**PLANNED UNIT DEVELOPMENT  
& SUBDIVISION STAFF REPORT****Date: June 5, 2008****DEVELOPMENT NAME** ZPM**SUBDIVISION NAME** ZPM Subdivision**LOCATION** South side of Grelot Road, 520'± East of Knollwood Drive.**CITY COUNCIL  
DISTRICT** District 6**AREA OF PROPERTY** 5 lots / 3± acres**CONTEMPLATED USE** Planned Unit Development Approval to allow multiple buildings on a single building site in a private street commercial subdivision, and Subdivision Approval to create 5 lots.**TIME SCHEDULE  
FOR DEVELOPMENT** Immediate**ENGINEERING  
COMMENTS**

### ***Revised for the July 24<sup>th</sup> Meeting***

# SITE PLAN

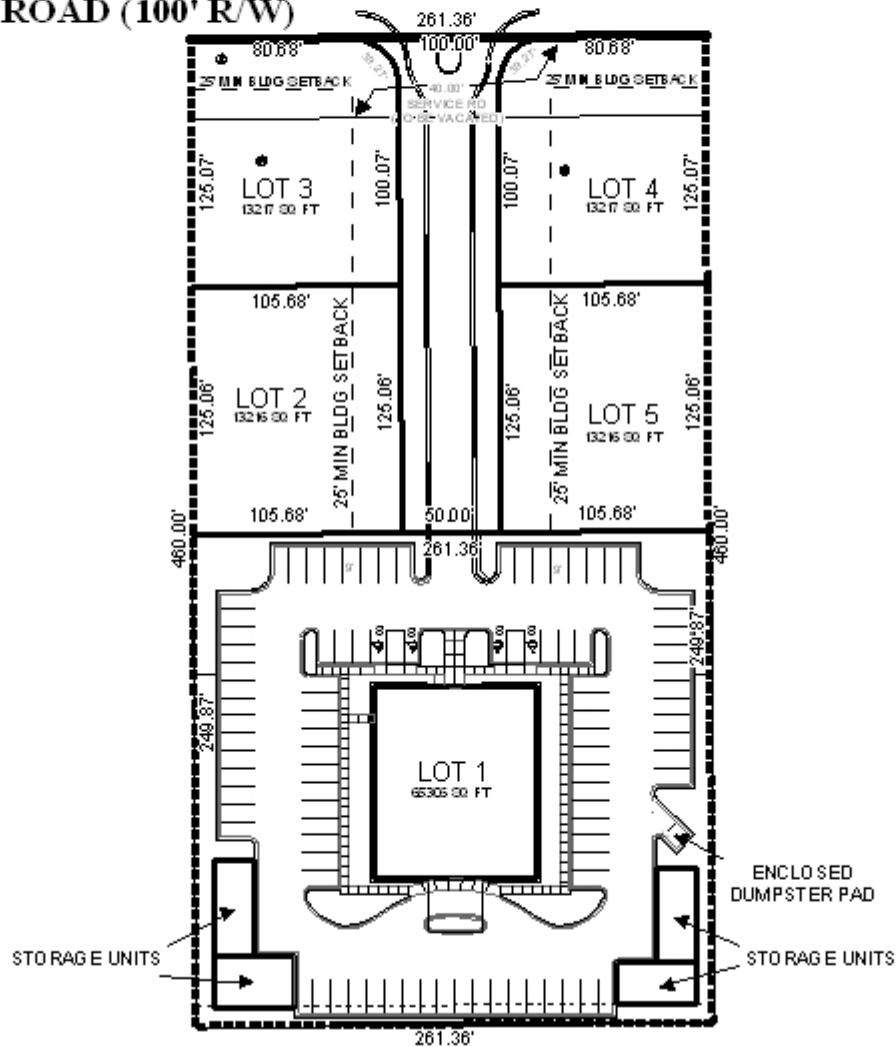
The plat illustrates an existing 40' service road right-of-way, which is noted as "to be vacated". This right-of-way must be vacated prior to recording of the final plat, if approved. As there are no existing service roads on this side of Grelot Road in this vicinity, and there is limited service road right-of-way, vacation may not be too difficult.

While the plat illustrates the required 25' setback(s), it does not provide a setback radius at the proposed intersection.

The plan illustrates the footprint of the building and several detached storage buildings. However, no information is given relating to the height of the building or storage units, nor is there any information provided as to the scope of use of those storage units, access, etc.

The plan does not depict any detention facilities. If such facilities are required, they should be illustrated as common area/detention facilities, and a note placed on the final plat stating that maintenance of the common area/detention facilities shall be maintained by the property owners association.

1. the private street be constructed in full compliance with Section VIII.E.2 (Standards);
2. submission of a revised PUD plan illustrating compliance with conditions of these approvals;

3. placement of a note on the revised PUD plan stating that Lots 3 and 4 are denied direct access to Grelot Road;
4. any required detention facilities be illustrated on the revised PUD plan as common area/detention facilities, and a note placed on the final plat stating that maintenance of the common area/detention facilities shall be maintained by the property owners association.

5. Placement of a note on the revised PUD plan stating that development of the site must be undertaken in compliance with all local, state and Federal regulations regarding endangered, threatened or otherwise protected species.

6. Placement of a note on the revised PUD plan stating that development of Lots 2-5 shall require new PUD Approval(s).
